# Access Compliance Report

## Public Rights-of-Way

Intersection ID: 47944	Main Street: SHARON_VIEW_RD	Cross Street: PHILLIPS_GATE_DR	Location:	N
ADA ID: 3CE07E0DF2AC	Ramp Type: BlendTrans2	Initial Pass/Fail: Pass	Overall Compliance: No	Severity Score: 2.5

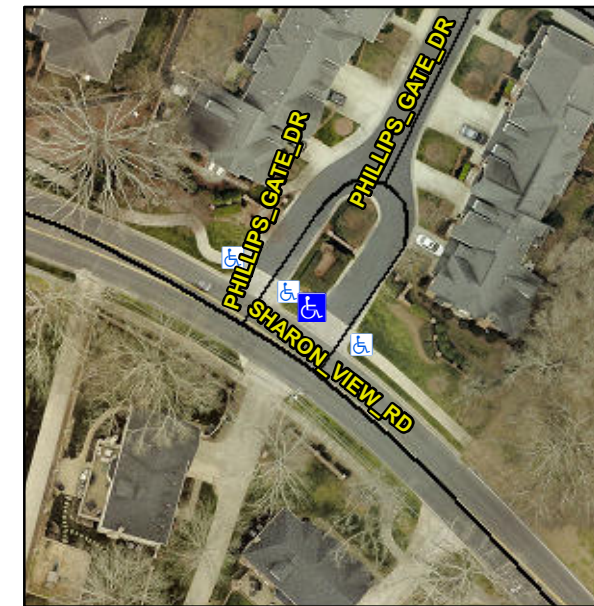
**Remove & Replace Detectable Warning System.**

**R305.1.4, R305.2**
